ADDENDUM NUMBER ONE

October 21, 2019

PIN 125590.00 Canada Road Pedestrian and Bike Trail

LIGHTING PLAN

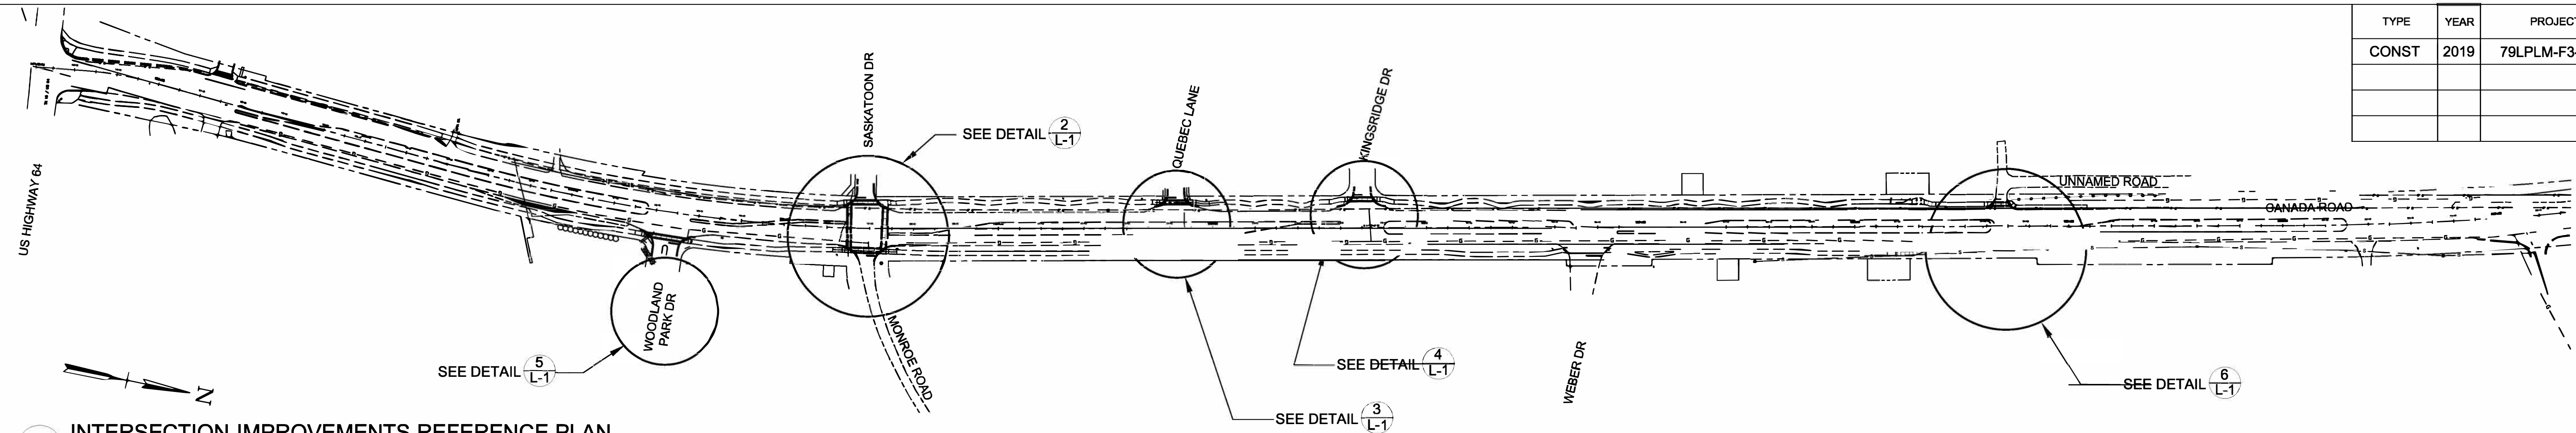
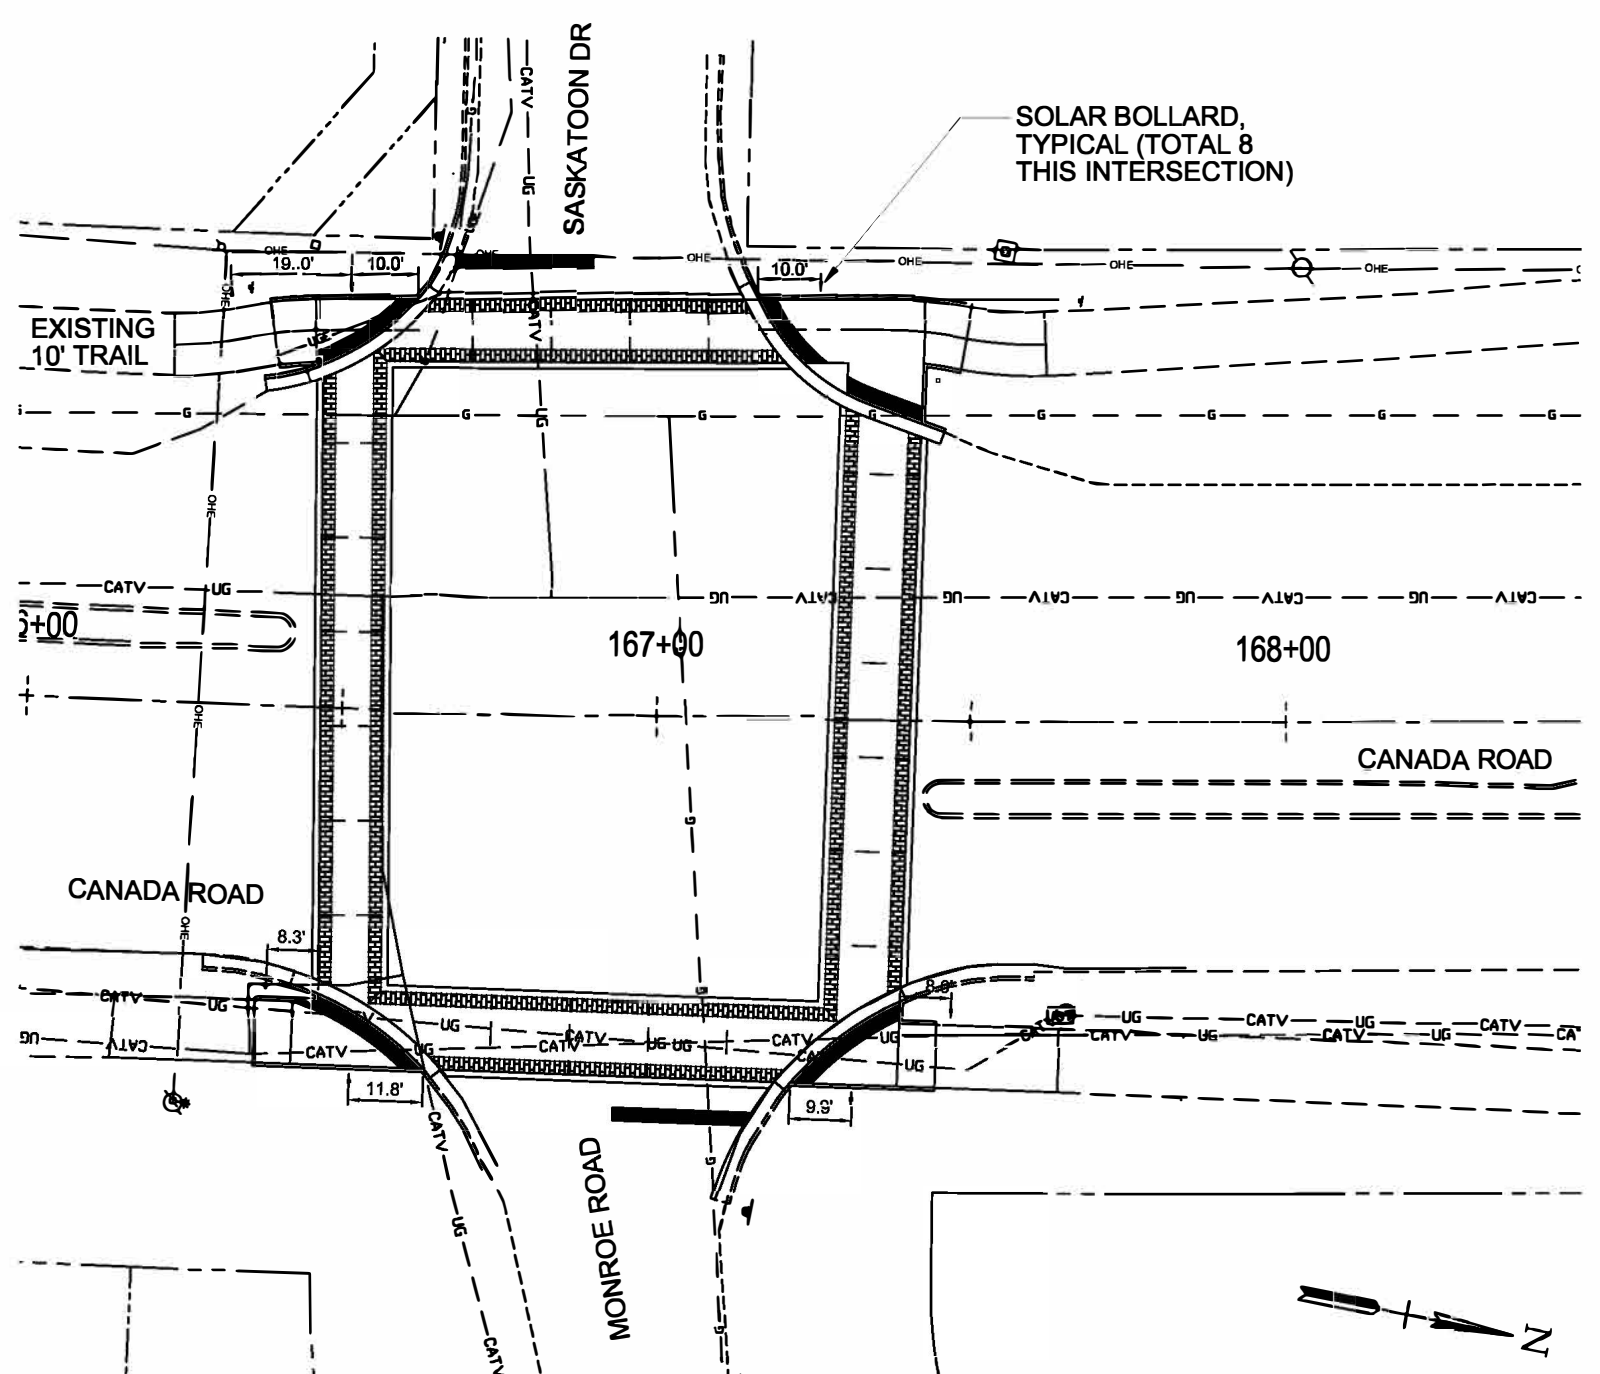
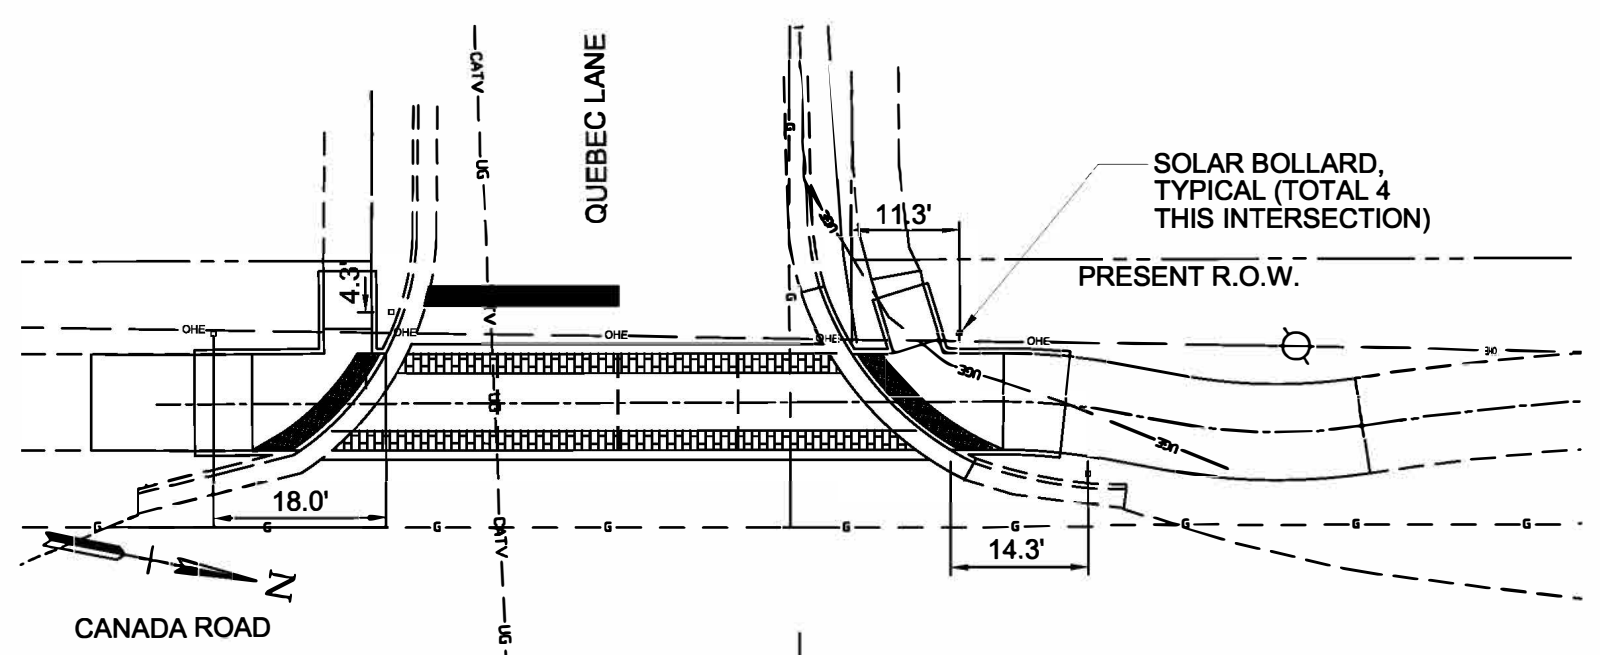
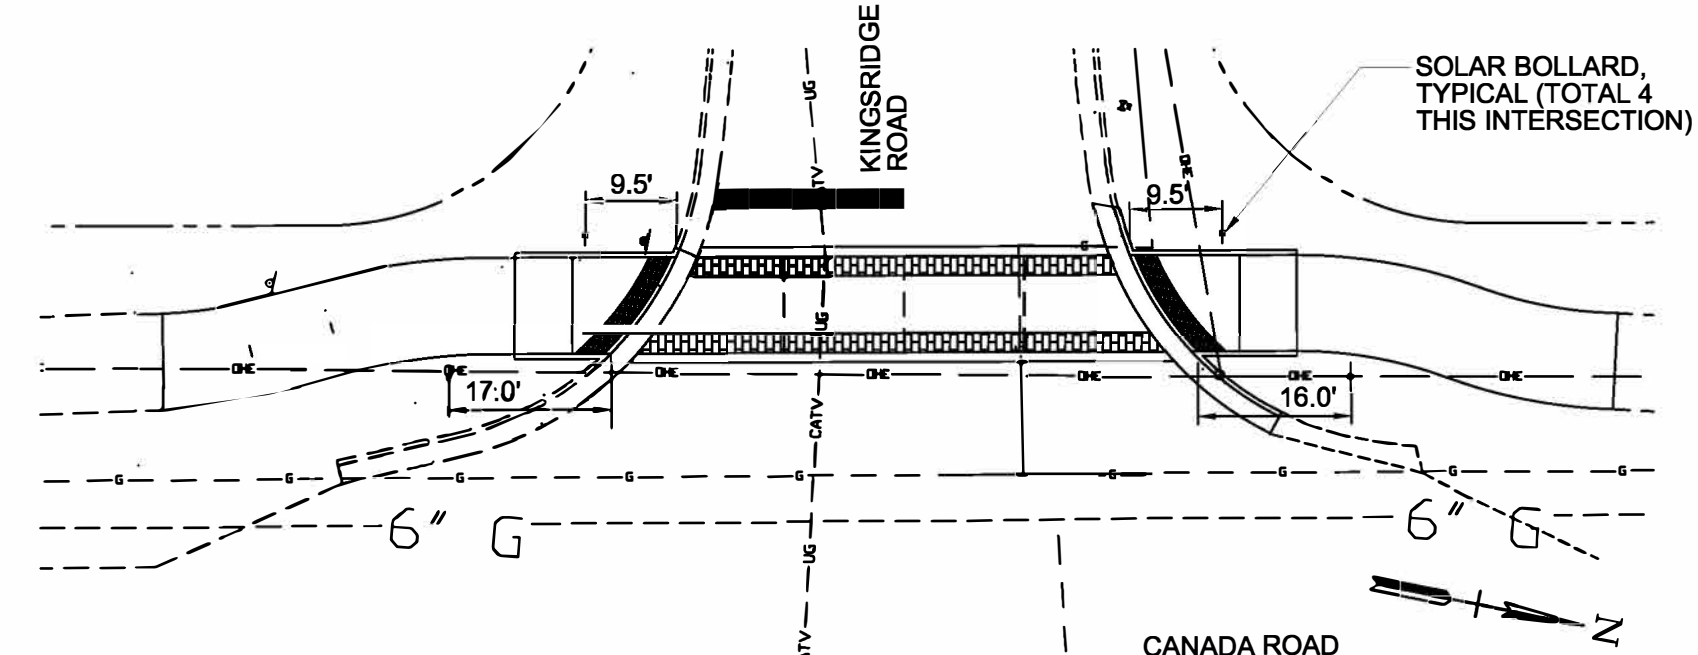
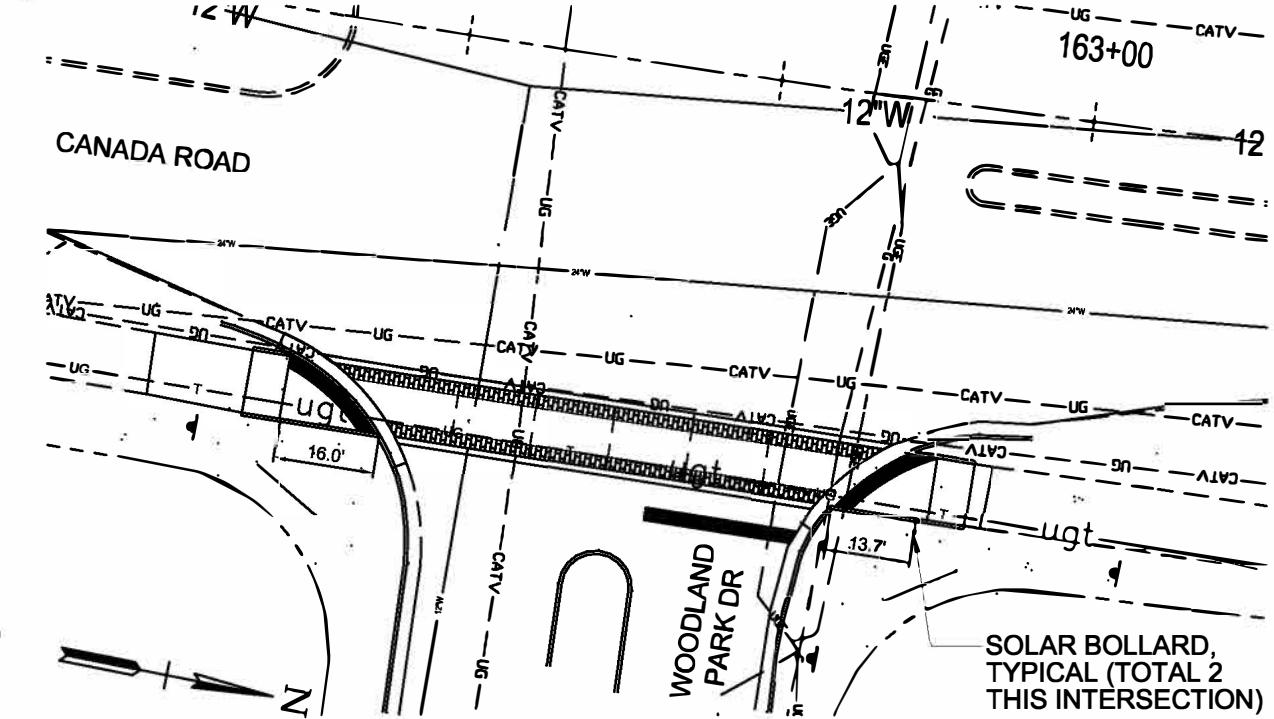
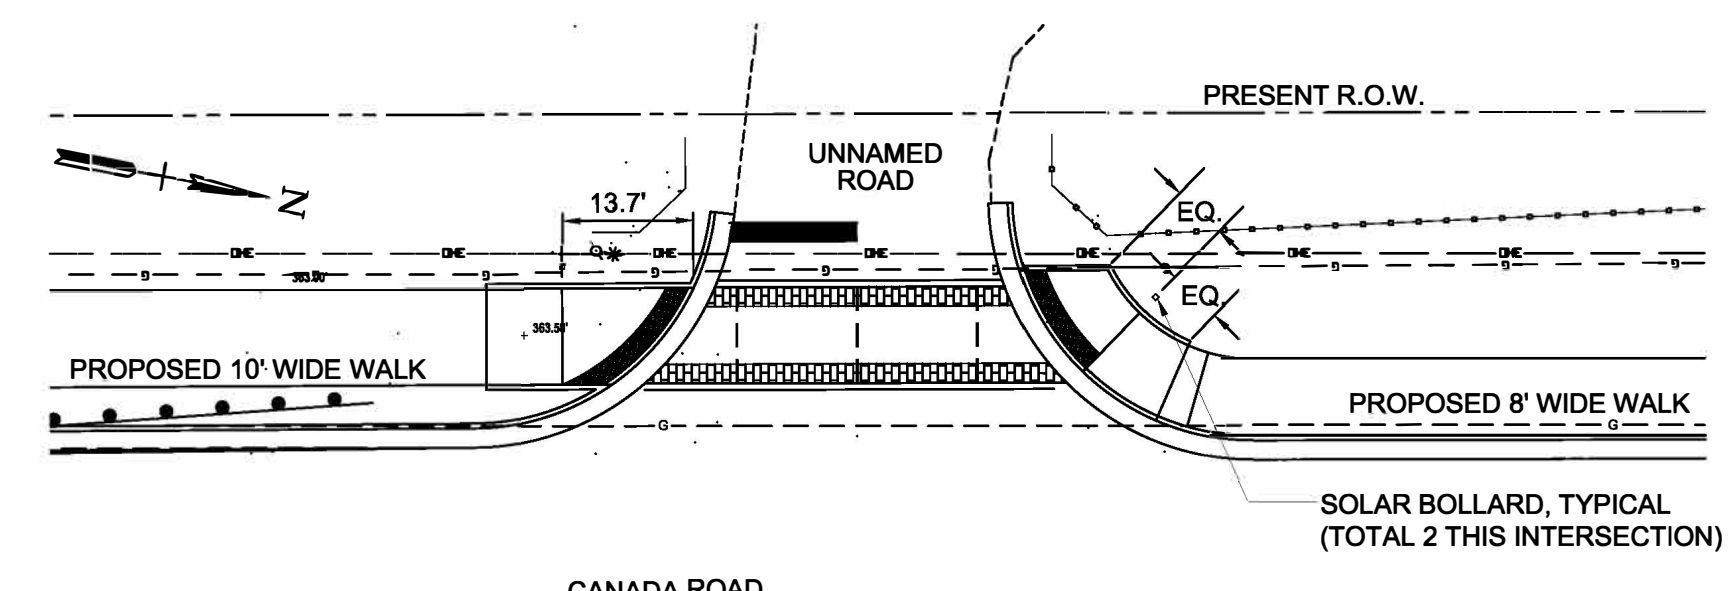
REFERENCE PLANS: SHEET L-1, LIGHTING PLAN

1. The key note “SEE DETAIL 9 / SHEET L-1” is in error. There is no lighting in the area referenced. This key note should be ignored.
2. Clarification of solar bollard operation. The solar bollards are intended to provide illumination of the intersections for pathway users, casting a wide distribution pattern of light. Minimum required operation is automatic lighting from dusk to dawn. The Owner will select the factory-programmed option for operation of the bollards. Optional motion sensors to provide a default dim illumination level, with pathway motion sensor activation for bright illumination level, is desirable but not required.
3. Lighting plans have been added to illustrate electrical connections for the proposed signs. This sheet replaces Sheet L-1, Lighting Plan originally issued.
